**GS# 104-215 Jones Hall Interior Renovations  
Mississippi University for Women**

Addendum No. 2

SHEET **M205**

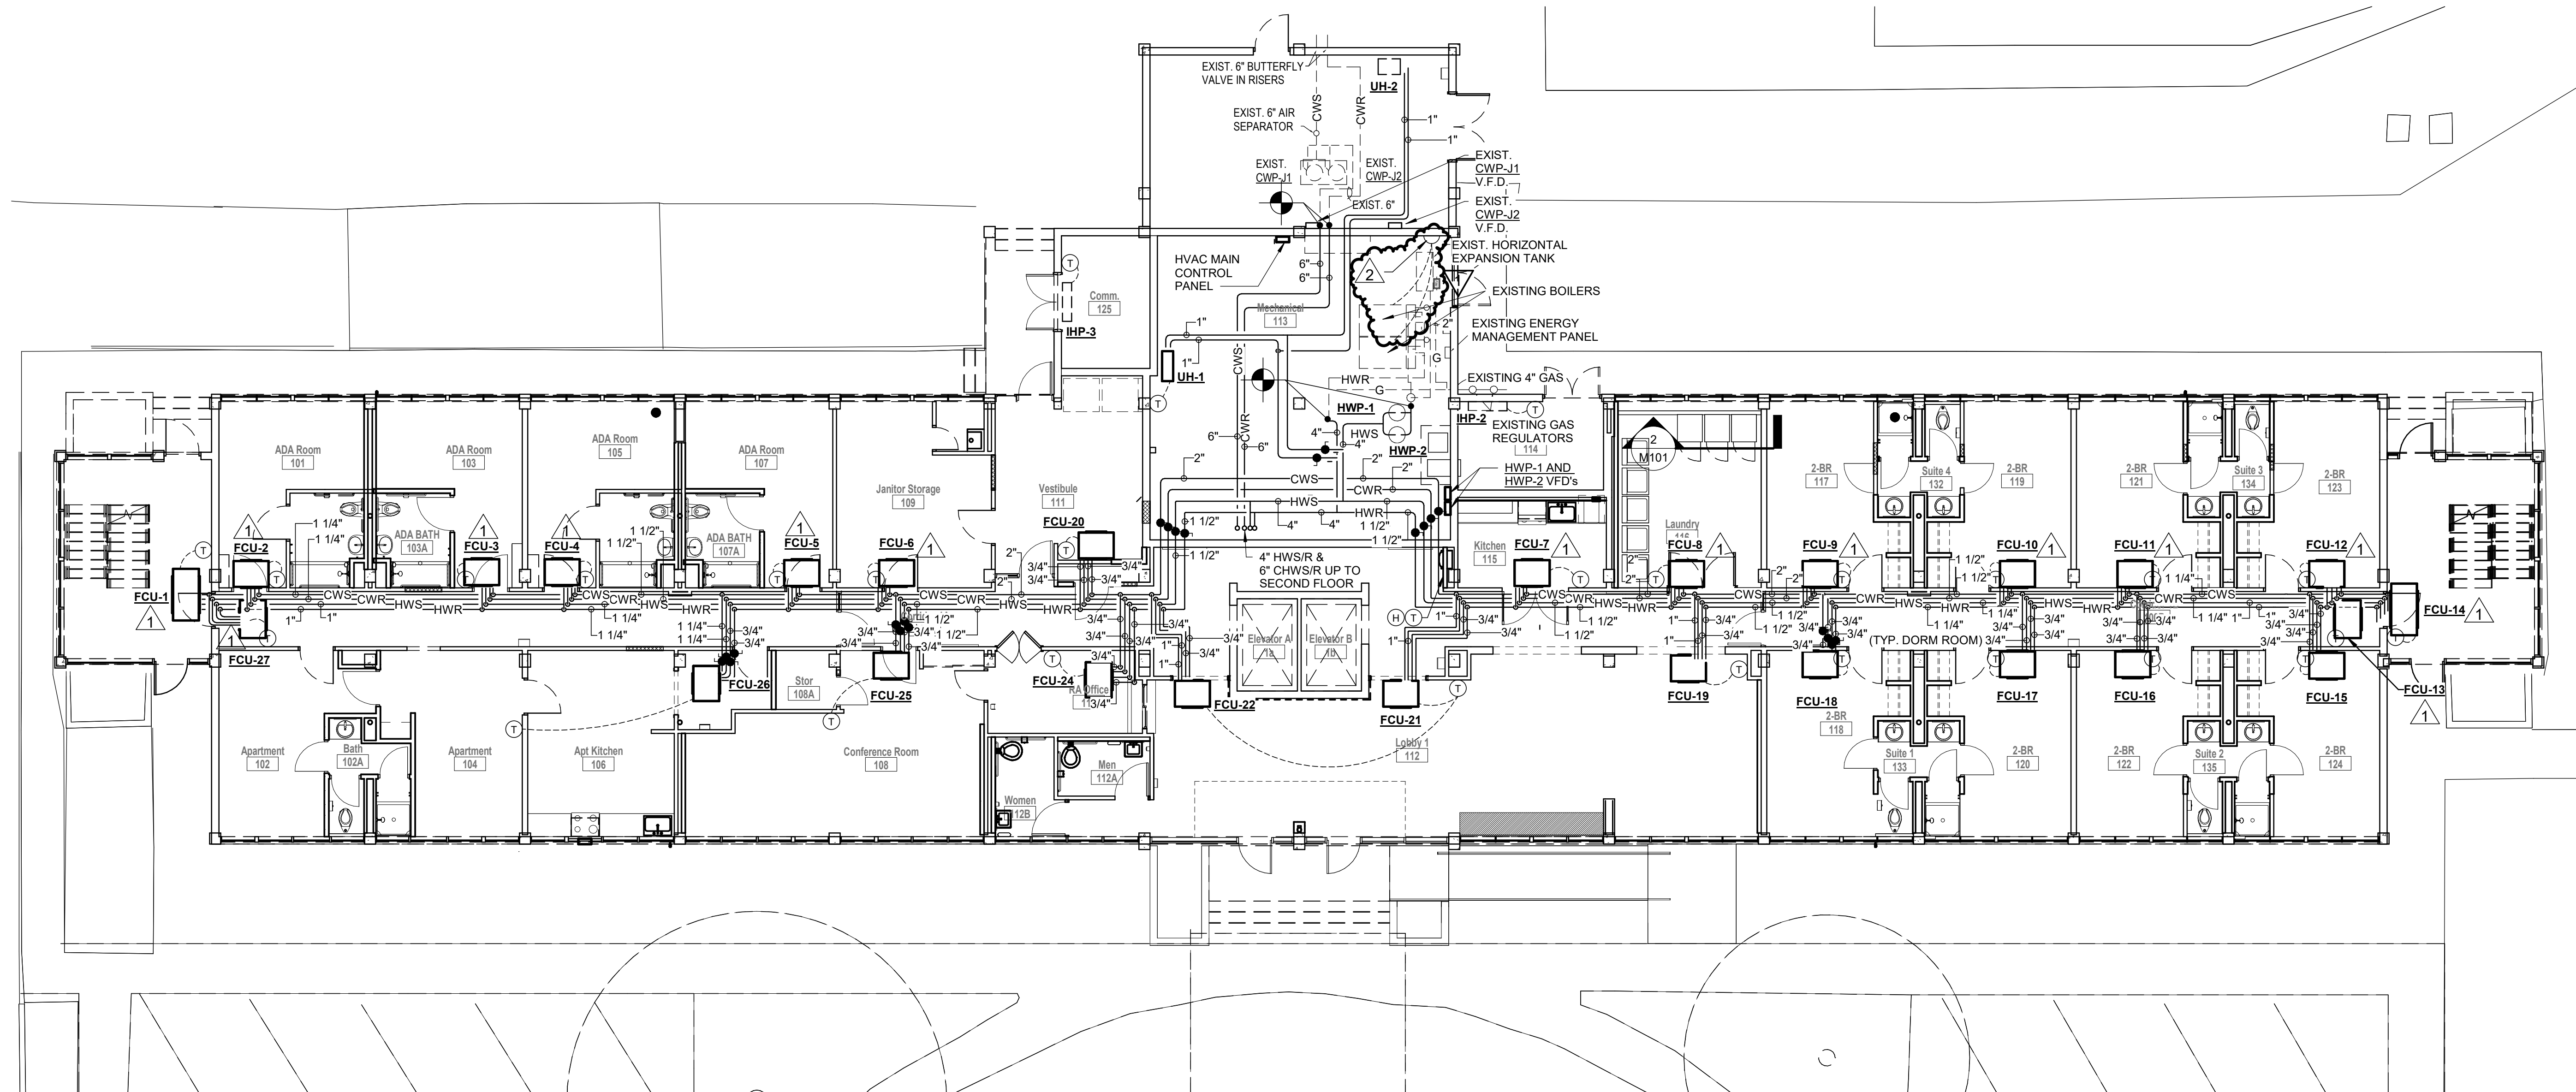
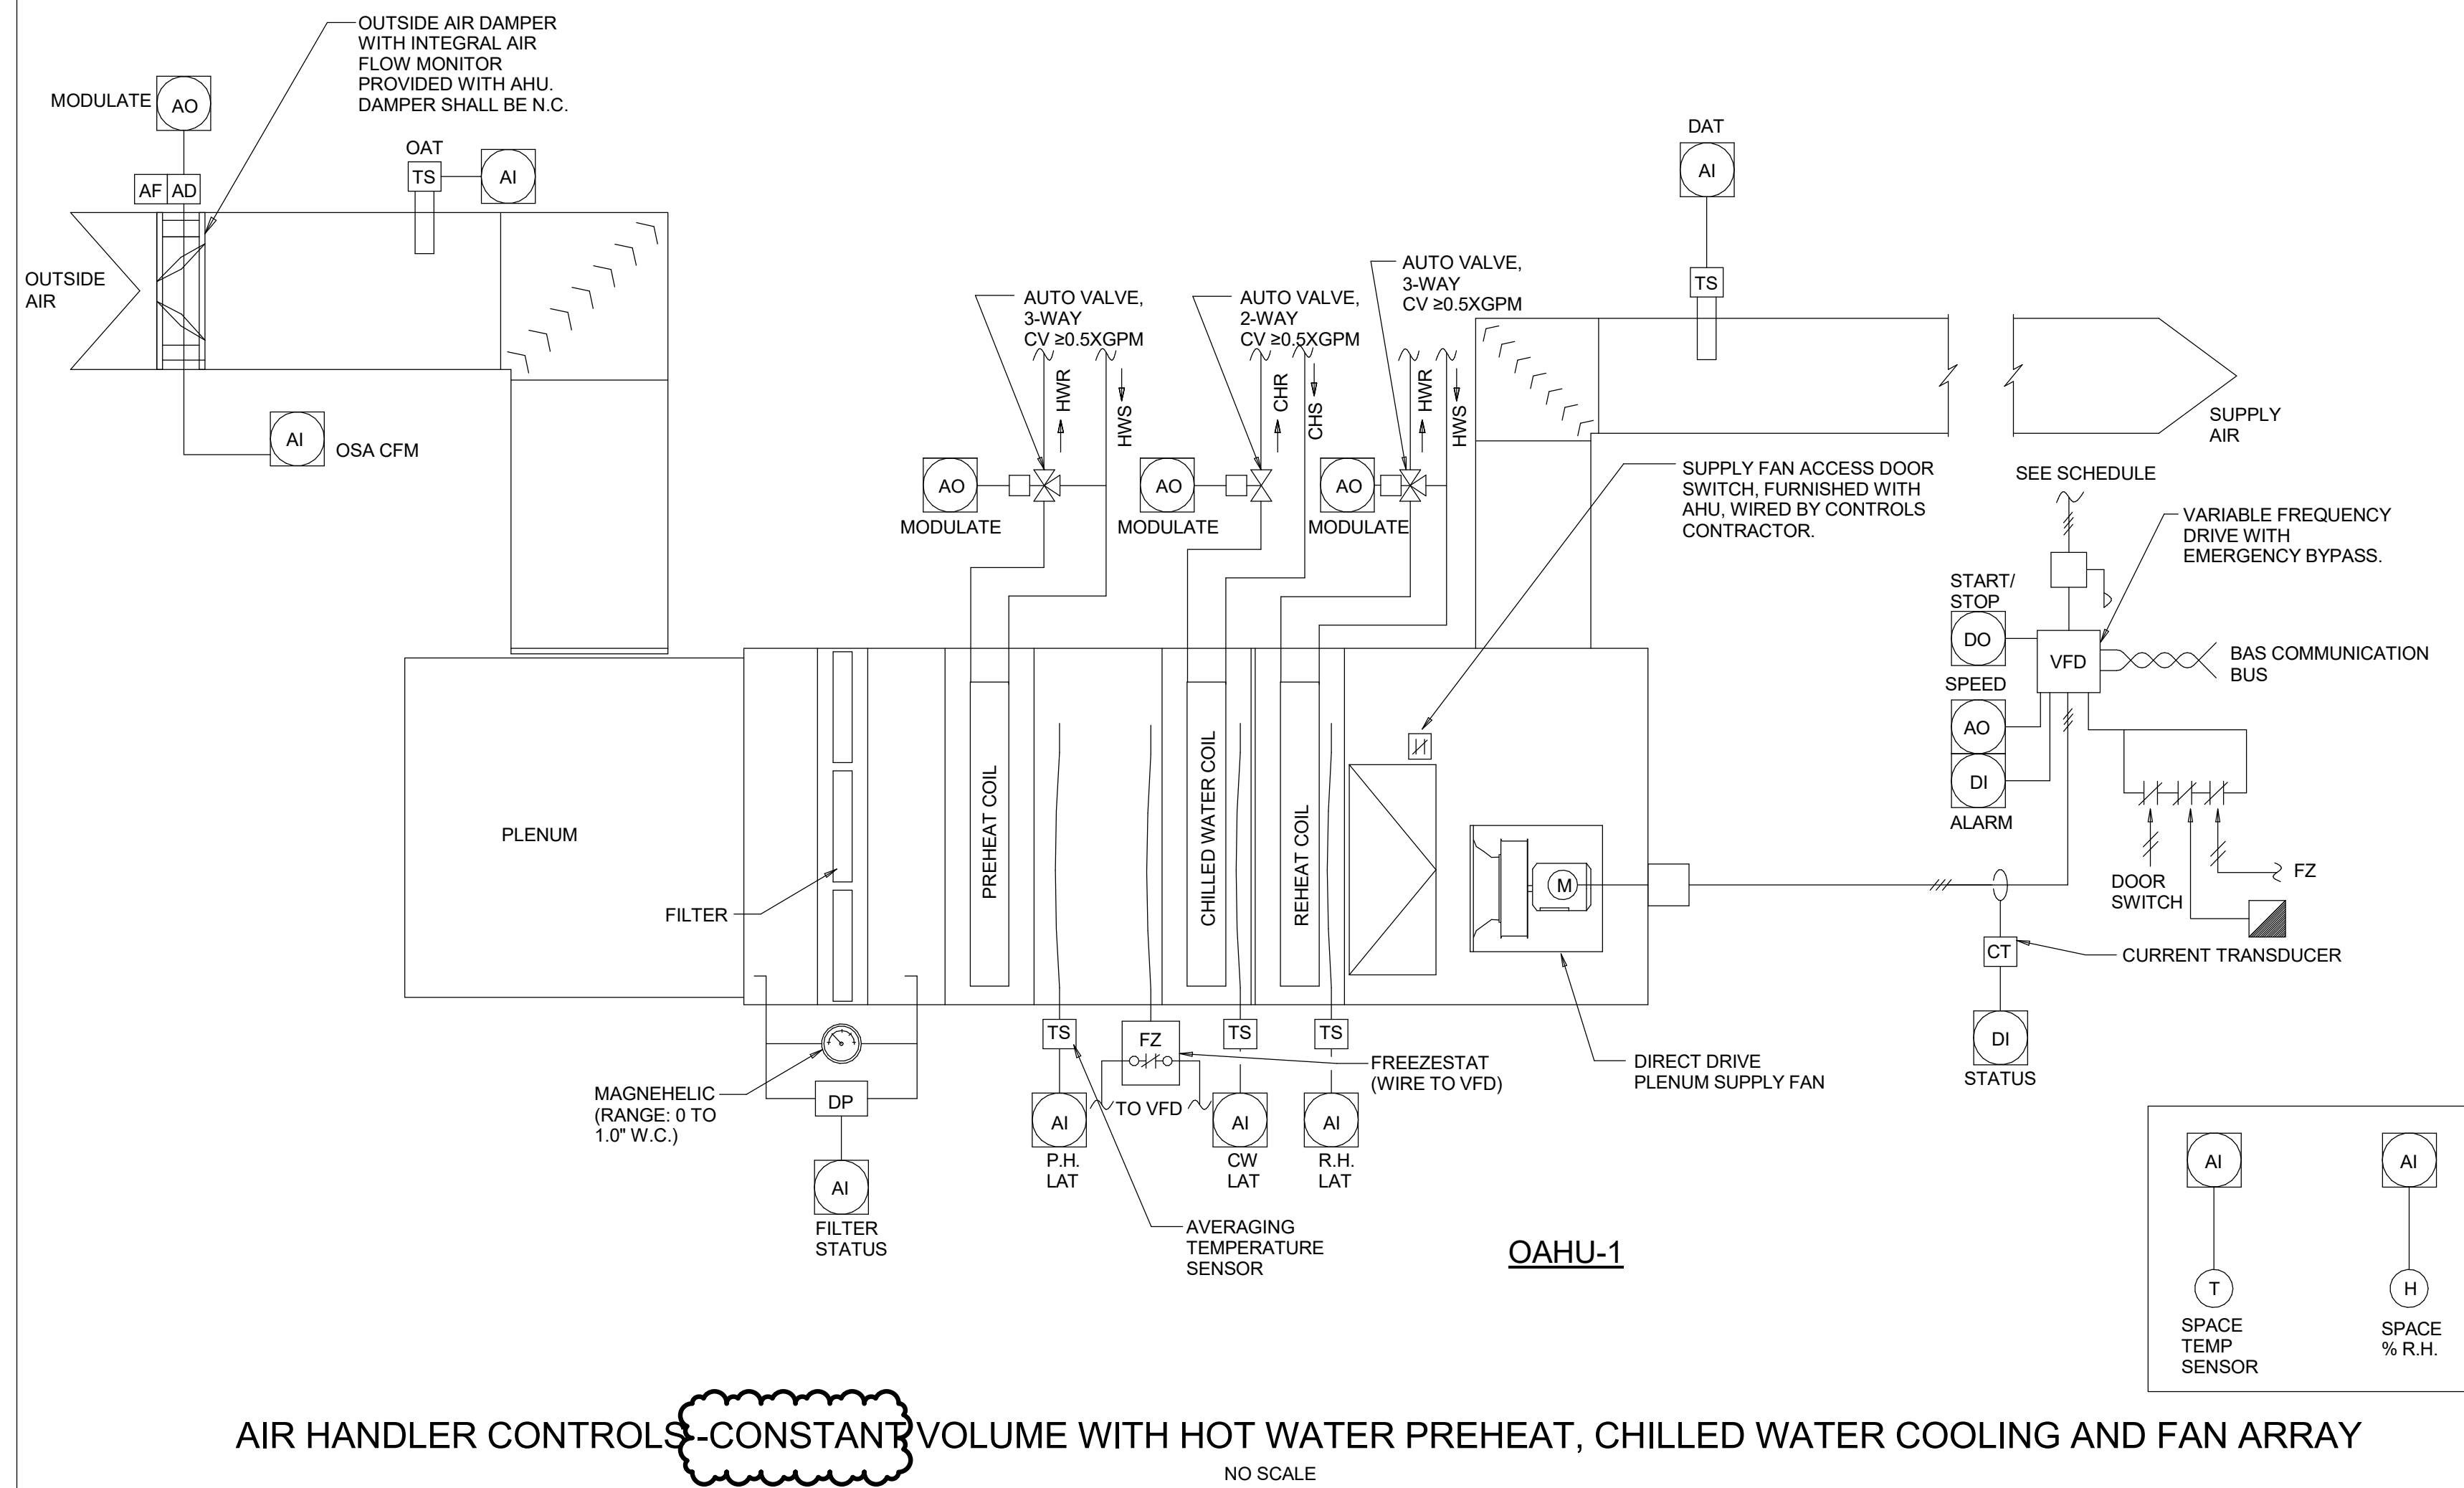
- k. Revise Sheet M202 and replace with attached Sheet M202. Revisions included revising EF-13 schedule.
- l. Revise Sheet M205 and replace with attached Sheet M205. Revisions included modifying the control sequence for OAHU-1 to match the specifications.

SHEET **MP101**

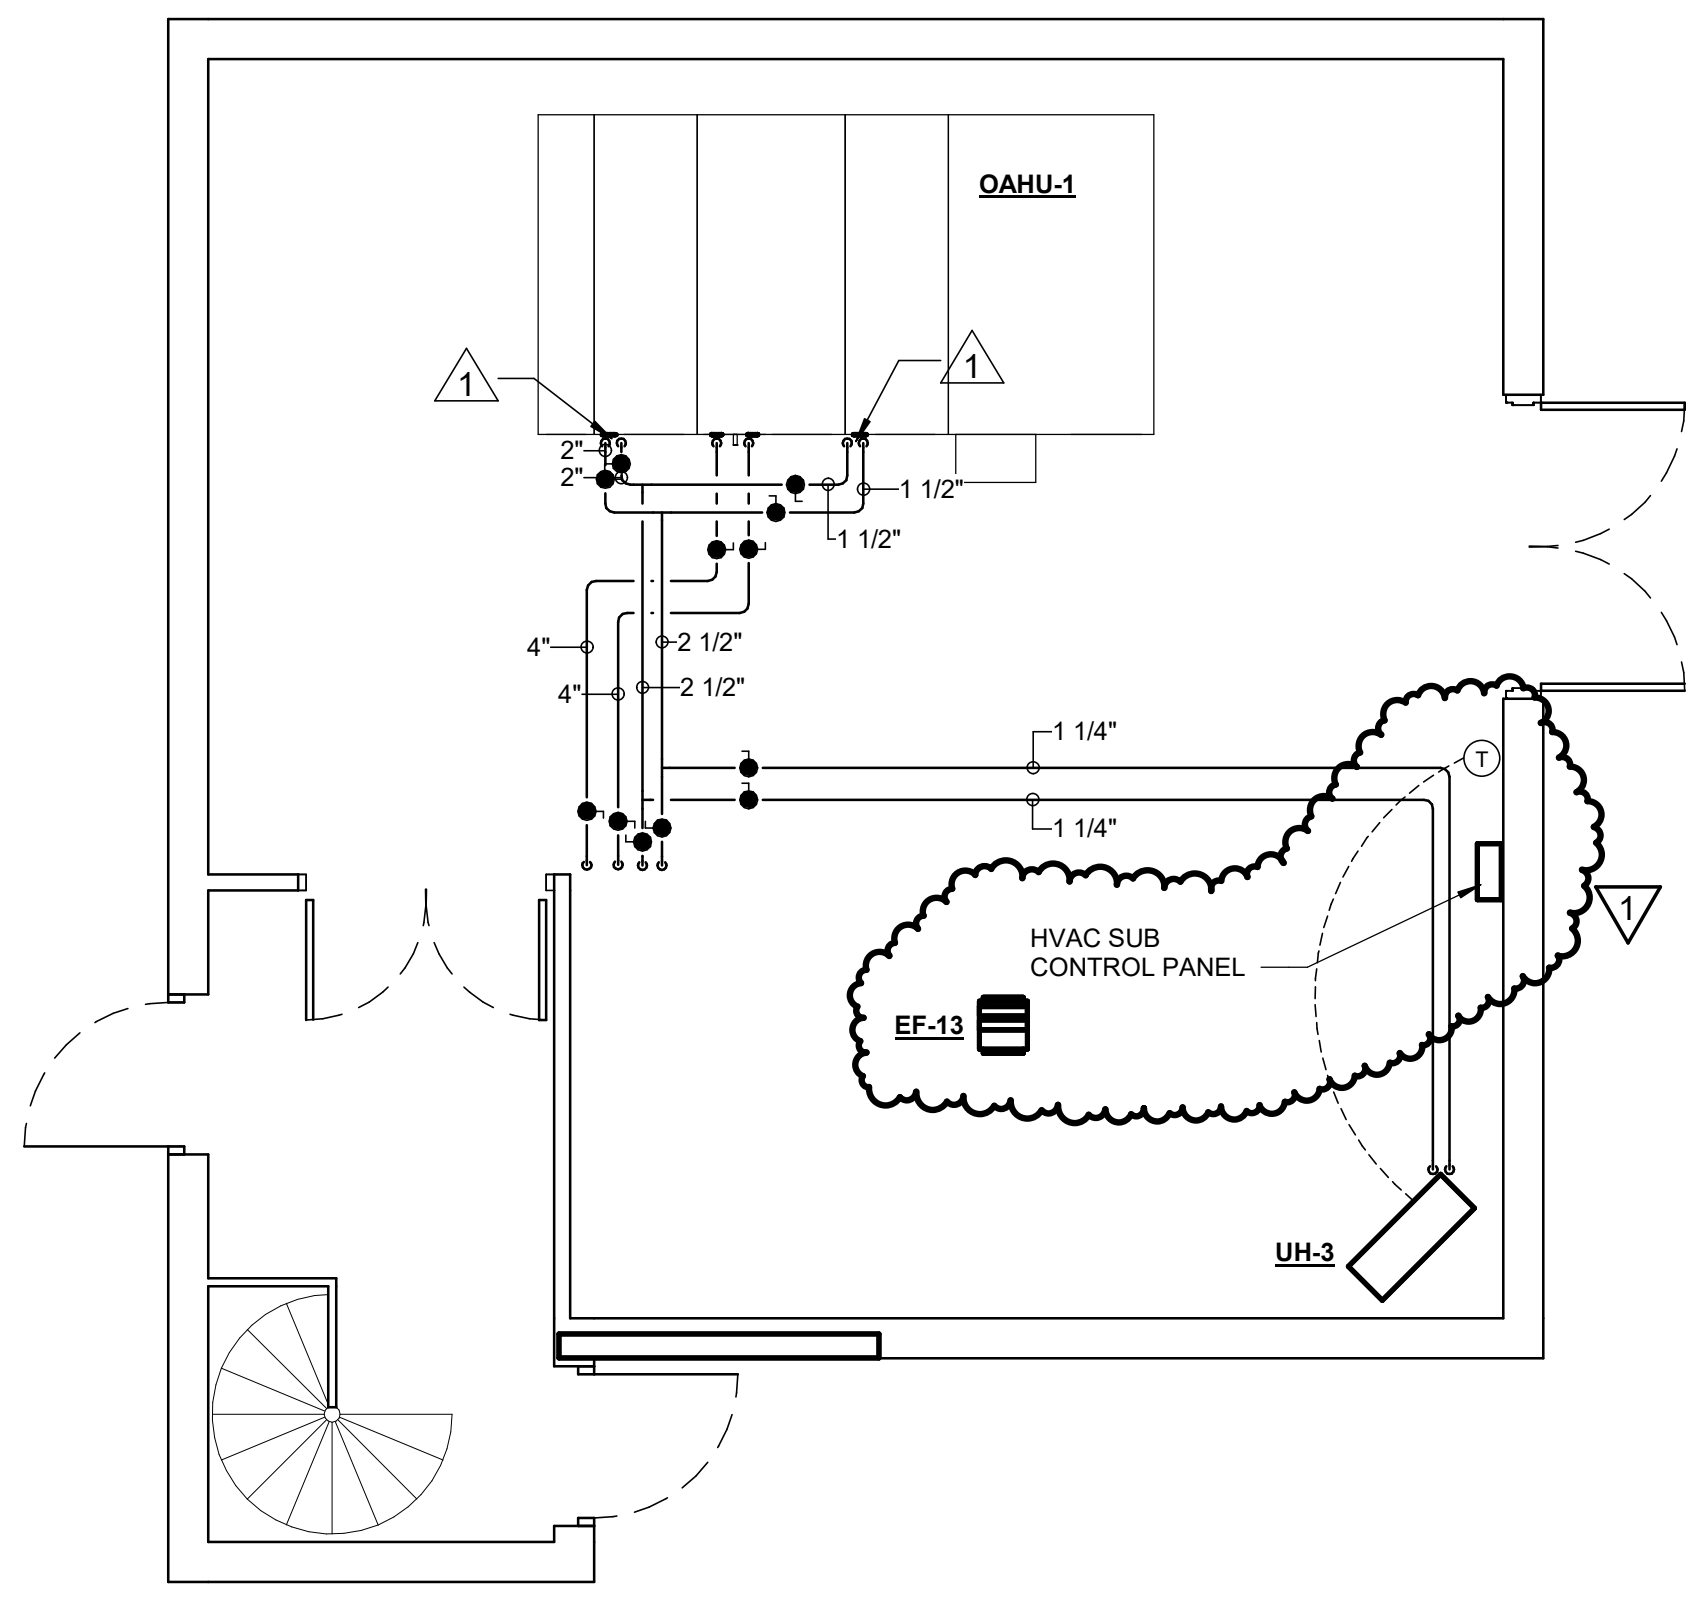
- m. Revise Sheet MP101 and replace with attached Sheet MP101. Revisions included replacing emergency boiler shut off with new button and control wiring.

**NOTES:**  
 1 3/4" HEATING AND CHILLED RETURN/SUPPLY WITH BALL VALVE.  
 2 PROVIDE NEW EMERGENCY SHUTOFF VALVE FOR GAS SERVICE TO EXISTING BOILERS. PROVIDE WITH NEW ISOLATIONS VALVES, DIRT LEG ASSEMBLY, EMERGENCY BUTTON AND CONTROL WIRING AS REQUIRED.
